UNITED STATES PATENT AND TRADEMARK OFFICE

| APPLICATION NO. | FILING DATE | FIRST NAMED INVENTOR | ATTORNEY DOCKET NO. | CONFIRMATION NO. |
|---|-------------|----------------------|---------------------|------------------|
| 10/645,670 | 08/22/2003 | Masaru Shimomura | 723-1421 | 8405 |

| Office Action Summary | Application No. | Applicant(s) | |

DETAILED ACTION

FIG.2

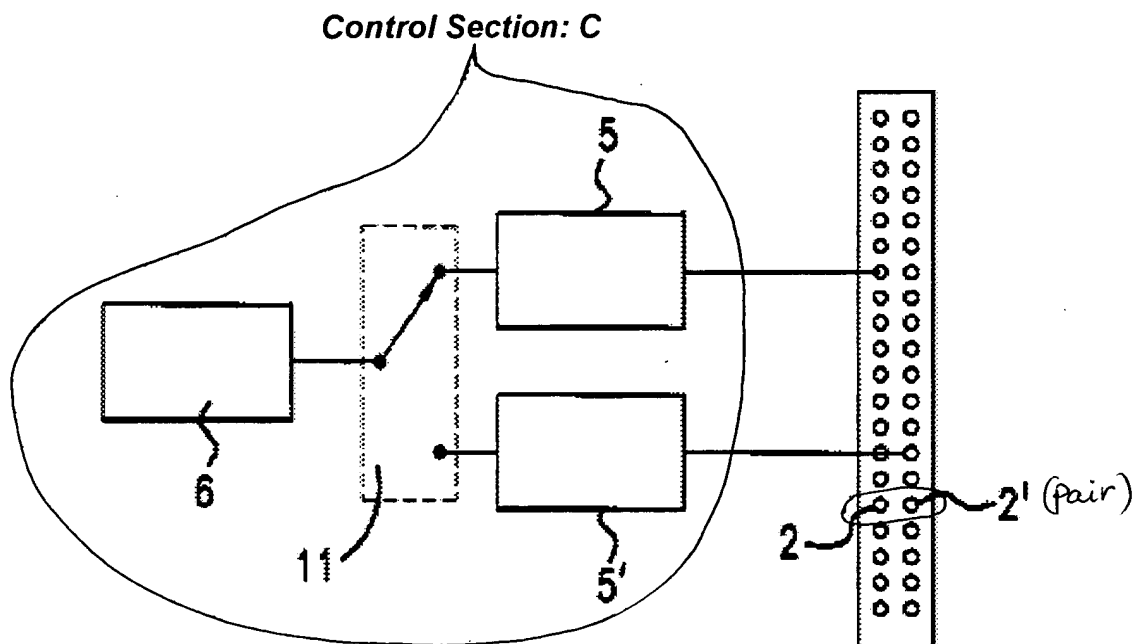
3. Claims 1 – 3 are rejected under 35 U.S.C. 102(b) as being anticipated by NakaMats (US Patent no. 6,249,998).

4. Regarding claim 1, NakaMats discloses a swing-type display device (fig. 2) for, when swung, displaying an image in a trajectory of the swing by utilizing persistence of vision, comprising:

a linear array of first light-emitting elements 2 (fig. 2) capable of emitting light in a predetermined color (col. 3, line 49), the linear array extending in a direction substantially perpendicular to the direction of the swing (figs. 4 and 5);

a linear array of second light-emitting elements 2' (fig. 2; col. 1, lines 61 and 62) capable of emitting light in a color which is different from the predetermined color (col. 3, line 49), the first light-emitting elements and the second light-emitting elements being

arranged in pairs of two, such that each second light-emitting element is disposed near a corresponding one of the first light-emitting elements (fig. 2); and

a control section C including circuits 5 and 5' (fig. 2; col. 2, lines 1 7) for activating each of the first and second light-emitting elements for a predetermined period to emit light in a luminance level in accordance with image data, thereby displaying an image corresponding to the image data in the trajectory of the swing (figs. 4 – 9; col. 2, lines 29+).

Regarding claim 2, NakaMats discloses the predetermined periods equal to period for displaying a single pixel of the image (col. 2, lines 29+).

Regarding claim 3, NakaMats discloses the first and second light-emitting elements of each pair are located side by side in the direction of the swing.
